## ADDENDUM NO. 03

<b>To:</b>	Brent Murray	<b>From:</b>	Josh Barsdorf
<b>Company:</b>	Vero Architecture		
<b>Date:</b>	June 1, 2026		
<b>Project:</b>	IH Layton Hospital PCH Exam Expansion

<< EY101 – LEVEL 3 AUXILIARY PLAN >>

**EY101**

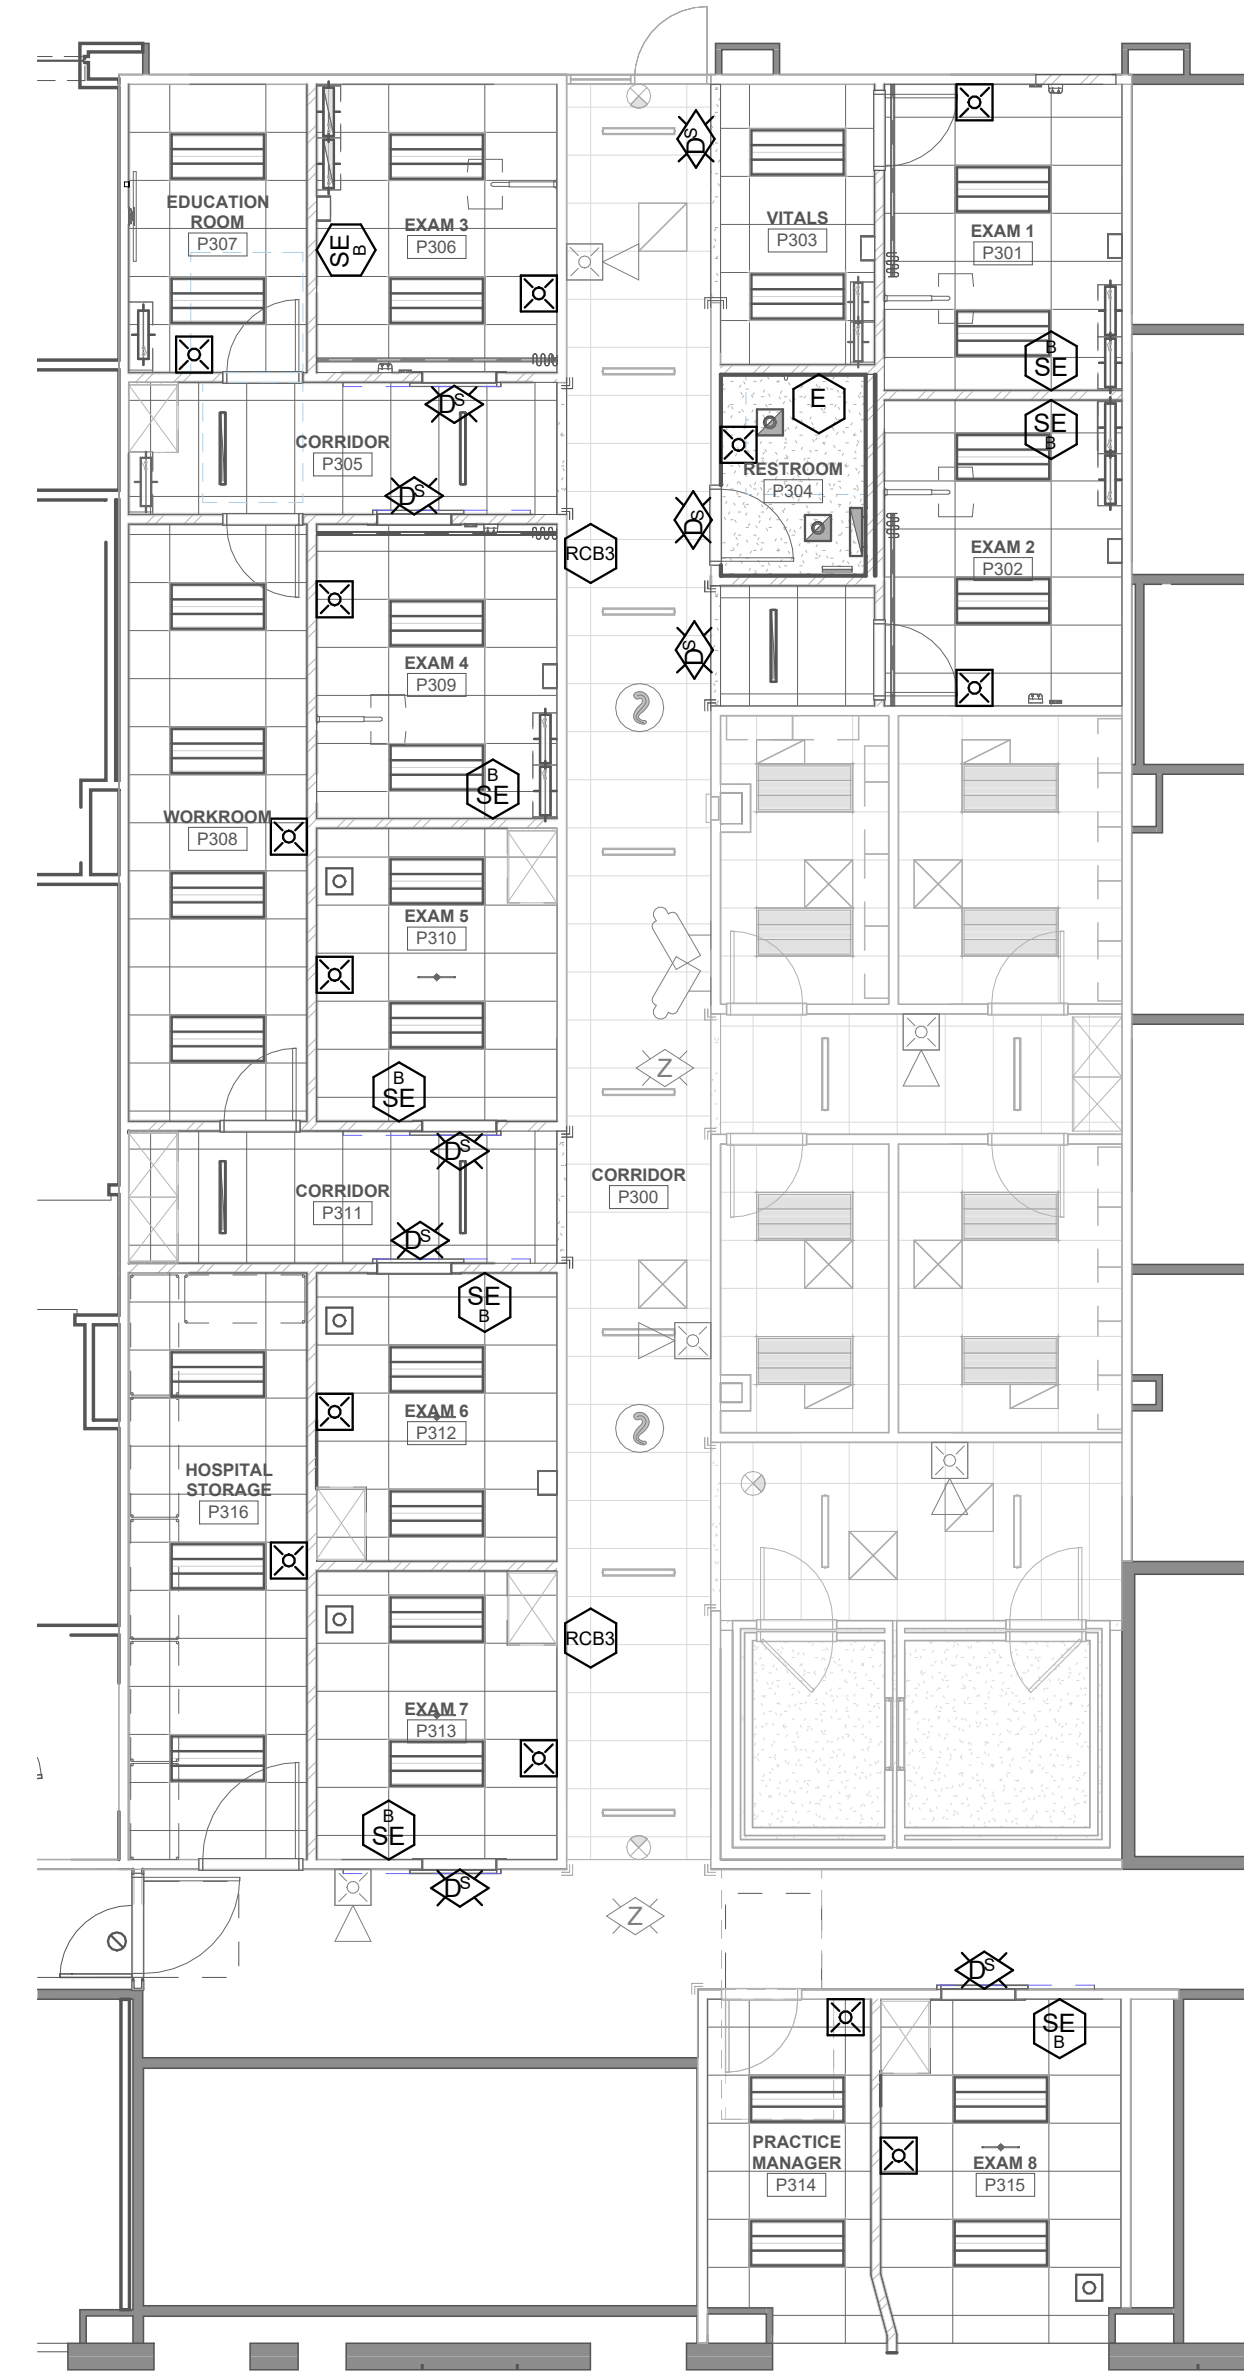
1. Revised keynote #3 to clarify fire alarm device raceway requirements.

- 1 ALL PATHWAYS FOR LOW VOLTAGE CABLING NOT REQUIRED TO BE IN CONDUITS SHALL BE ROUTED IN J-HOOK PATHWAYS. CONCEAL ALL PATHWAYS ABOVE ACCESSIBLE CEILING SPACES. DO NOT RUN CABLES IN EXPOSED AREAS. WHERE CONCEALMENT IS NOT POSSIBLE IN EXPOSED AREAS, CONTRACTOR SHALL PROVIDE CONDUIT TO ROUTE CABLING WHERE VISIBLE. ALL CONDUIT SHALL BE PAINTED TO MATCH CEILING AND PROVIDED WITH PROTECTIVE BUSHINGS. REFER TO TELECOM RACEWAY PLANS FOR ADDITIONAL INFORMATION.
- 2 SEE ARCHITECTURAL ELEVATIONS AND REFLECTED CEILING PLANS FOR DEVICE LOCATIONS. IF NOT SHOWN ON ARCHITECTURAL DRAWINGS LOCATE PER TYPICAL DEVICE MOUNTING DETAILS ON SHEET EE701. ALL CEILING MOUNTED DEVICES SHALL ALIGN WITH OTHER DEVICES ON CEILING.
- 3 FIRE ALARM DEVICE CIRCUITS TO BE RUN IN FACTORY-FINISHED RED CONDUIT (3/4" CND Min).
